82559 Fast Ethernet Multifunction PCI/CardBus Controller

Stepping Information

October 2004

Revision 2.2

6. Premature Clamping of Electrostatic Discharge Circuitry

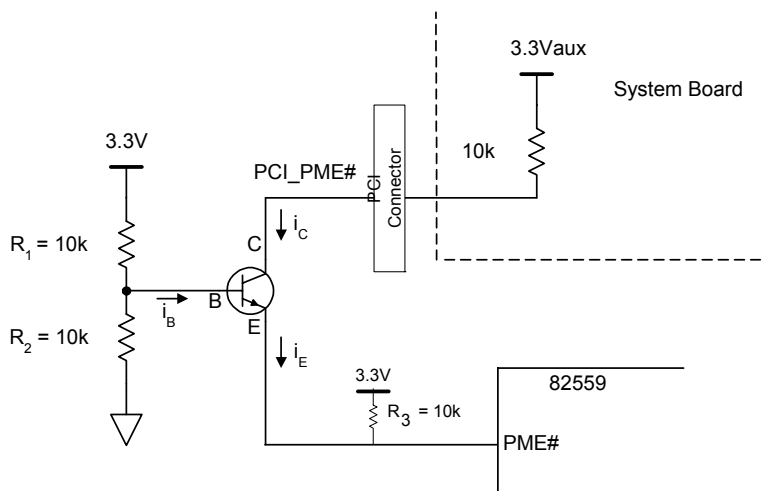
Problem: The Electrostatic Discharge (ESD) protection circuit of the 82559 B-step attempts to clamp bus signal levels when driven to a 5 V level. A direct diode connection to the 3.3 V power supply does not exist. Instead, the circuit configuration contains a 150 Ω resistor in series with the 82559's internal diode. This causes the clamping circuitry to limit the maximum signal level to four volts. Six specific signal pins (PCI signals Initialization Device Select, Reset, Clock, and Grant and device signals Alternate Reset and Isolate) are affected by this anomaly. This issue does not degrade AC timing or ESD protection.

Implication: This anomaly is limited to systems using a hard +5 V signal level on the PCI bus. When a +5 V level is applied to specific pins of the 82559 B-step, the protection circuitry engages. This causes the pins to sink additional current as the lines are held to approximately four volts. This

phenomenon is limited to six specific signal pins (PCI signals: Initialization Device Select, Reset, Clock, and Grant; device pins: Alternate Reset and Isolate). Currently, most platforms use 5 V tolerant 3.3 V devices to drive the PCI bus. The 82559 is one such device and does not draw any additional current into these pins. In legacy systems that use 5 V core devices (in other words, these signals are driven to 5 volts), the pins will draw additional current. This should not be a serious concern since all signals will still be maintained at valid logic levels and degradation in device longevity will not occur. Based on thorough analysis of this anomaly, there are no detrimental effects on system performance.

Workaround: In practical applications, no system changes are required for this anomaly. This is based on the understanding that the 82559 is normally driven by 3.3 V signals. In systems where +5 V devices may be driving the 82559, current limiting may be employed to protect the devices driving the 82559. Serial resistors may be added without any significant effect on signal quality.

Extensive testing of the 82559 with worst case current sinking has been performed. The results show that additional failures in seven years of constant operation should not occur due to this anomaly.

7. False Power Management Event Indication on Power Cycle

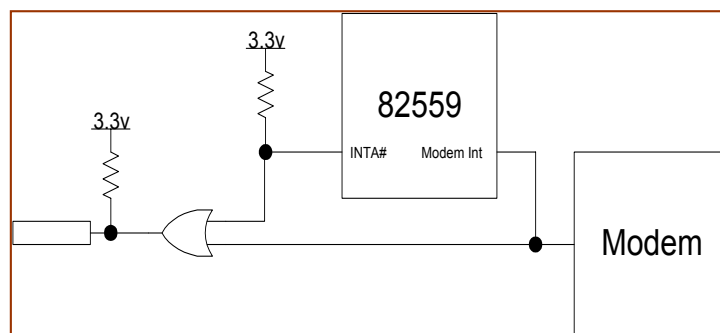
Problem: During power cycle events, the electrostatic discharge (ESD) elements internal to the 82559 may falsely clamp the Power Management Event (PME) output signal to approximately 1.5 volts for 100 ms to 150 ms during initial power up. This can cause wake-up events to be recognized by the system if power management events are enabled in the system chipset. This may result in a problem for mobile environments since the false clamping can cause a suspended system to wake up when the power to the LAN device is transitioned.

Implication: The implications of this anomaly depend on the target system configuration. In desktop and server systems, the impact is limited to a false wake-up event occurring when a new card is installed. In mobile systems where the LAN power is transitioned more frequently, the PME signal should be disabled during transitions.

Workaround: False PME indications can be avoided by disabling the recognition of a PME before removing or restoring power to the 82559. If a hardware solution is required, the following isolation circuit has been proven to be effective. The circuit requires the PCI PME signal (PCI_PME#) to be isolated from the 82559 PME signal (PME#). The system does not see the 1.5 voltage level drop caused by the 82559's power transition.

12. Potential Receive Overrun in Dynamic Standby Mode

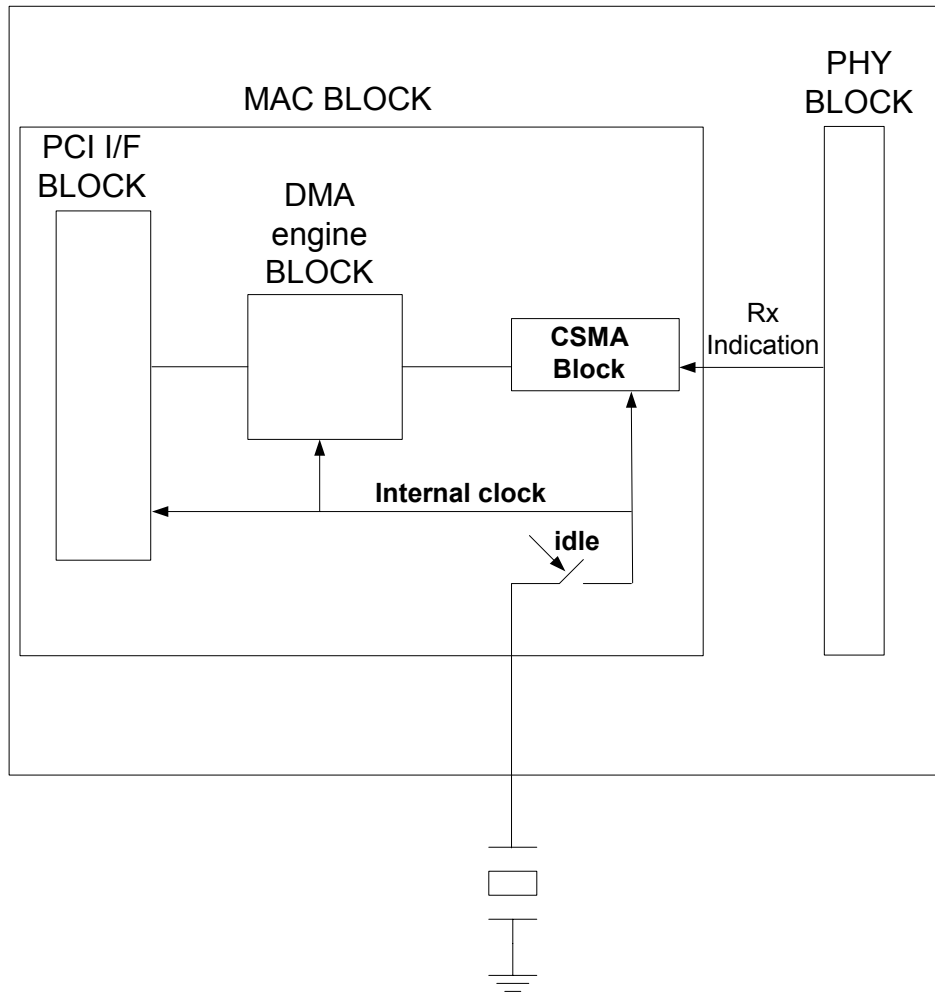
This issue can affect all design implementations using the 82559 (B-step) LAN Controller.

Problem: The 82559 (B-step) supports a Dynamic Standby mode. In this mode, the 82559 powers down certain logic blocks to save power during periods of inactivity. It automatically switches to Dynamic Standby Mode when it is in Idle mode and Dynamic Standby mode is enabled.

In Dynamic Standby mode, a possible synchronization condition may occur preventing the device from waking up when it receives an incoming frame. If this happens, the frame is not properly handled and is lost.

Workaround: To avoid potential receive overruns, the Standby Enable bit in the EEPROM (Word 0Ah, bit 1) should be set to 0b. This results in increased power consumption of approximately 40 mW. (A DOS-based utility is available through your local Intel sales representative to disable the Standby Enable bit in the EEPROM.)
